MONTGOMERY COUNTY PLANNING DEPARTMENT  
THE MARYLAND-NATIONAL CAPITAL PARK AND PLANNING COMMISSION

**MEMORANDUM**

**REVIEW TYPE:** Preliminary Plan of Subdivision

**PROJECT NAME:** Sellar Property

SELLAR PROPERTY (120080120)

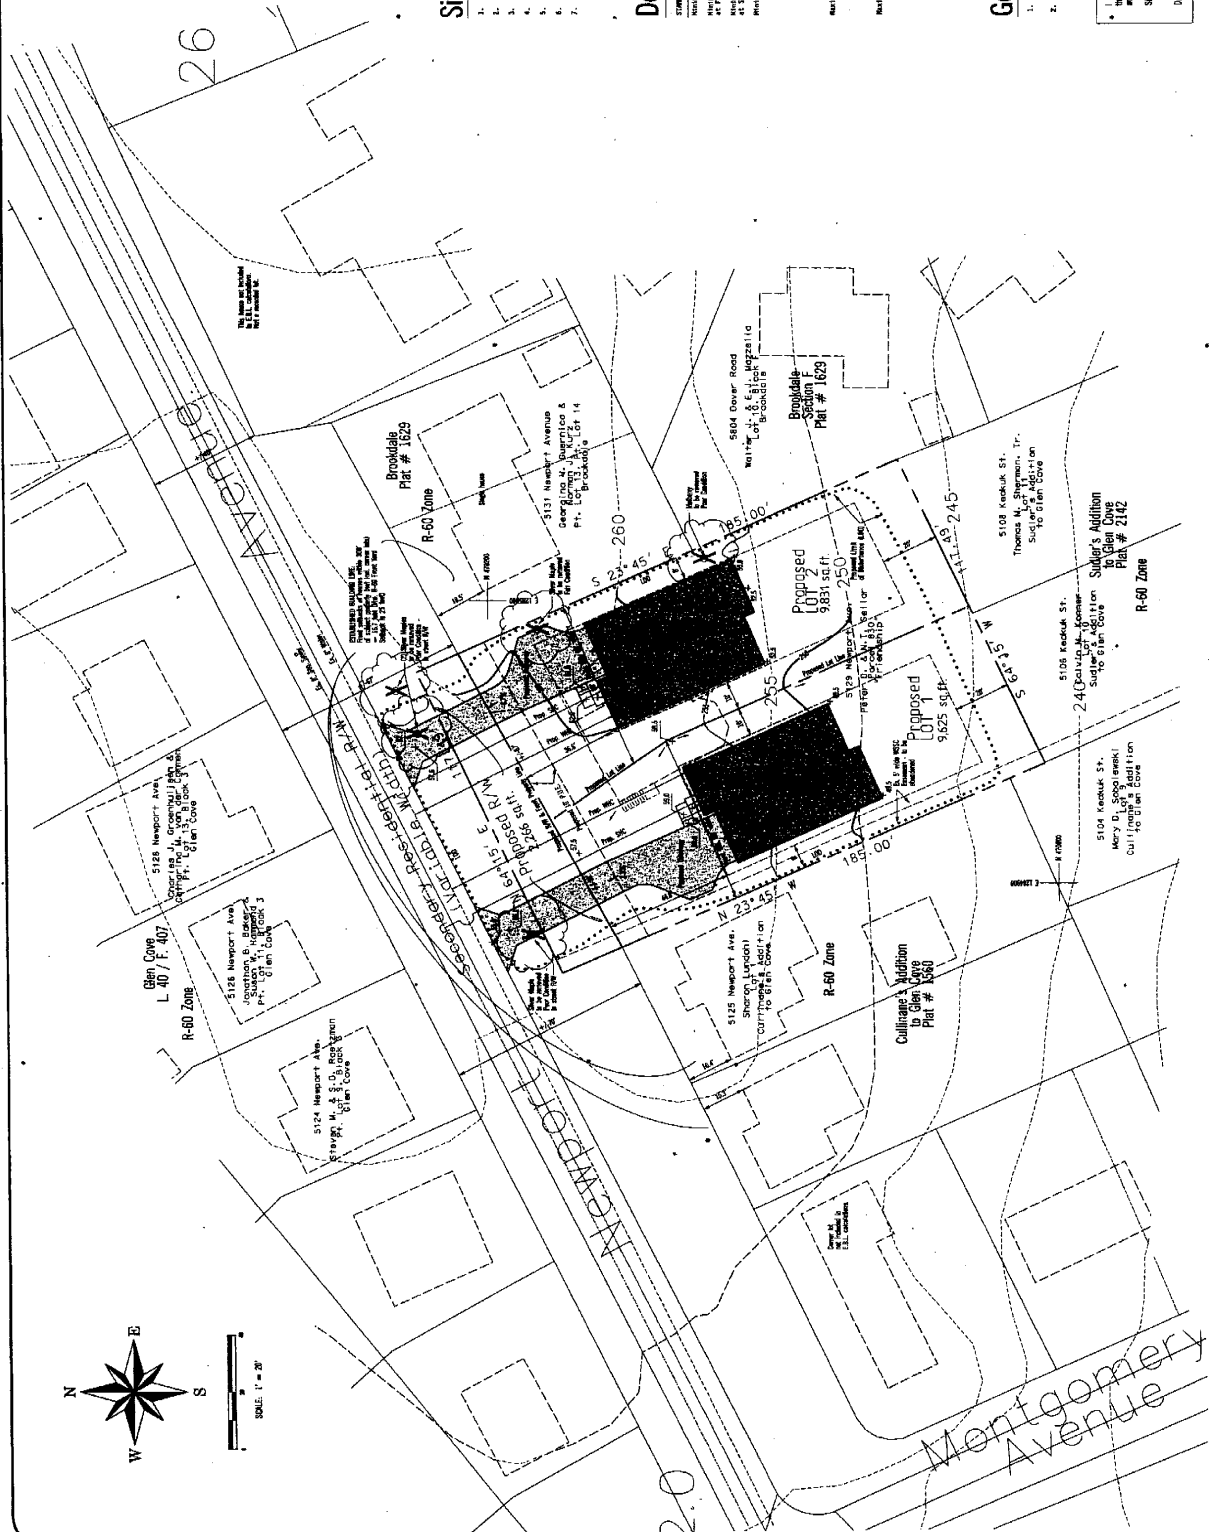
The subject property, shown below and in Attachment A, is an unplatted parcel measuring 0.5 acres within the R-60 zone. The property is located on the south side of Newport Avenue, approximately 500 feet west of River Road (MD 190). The site is currently developed with a one-family residence, which is proposed to be removed to accommodate the subdivision. Properties surrounding the site to the north, south, east, and west are developed with one-family residences and are zoned R-60.
